Service Bulletin

No. : MZ03-030

Model: SR7300.SR7300F

Subject: RS232C control is changed to "new protocol".

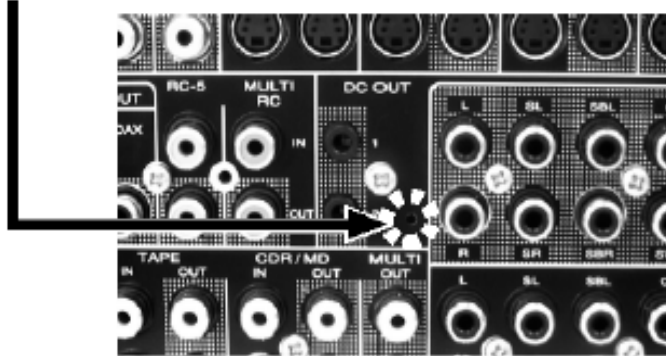
Symptom: The CPU software has changed. The specifications of the set are the same as the SR9300.

Solution: 1. Update the CPU (QU01) firmware version to "V030502_1"
2. Please refer to the service manual SR7300/SR7300F/PS7300 page 53 for details of "10.UPDATE FIRMWARE" Download Firmware for CPU (Mode2).
3. Update the firmware. (file name: SR7300_H8_030502_1.zip).
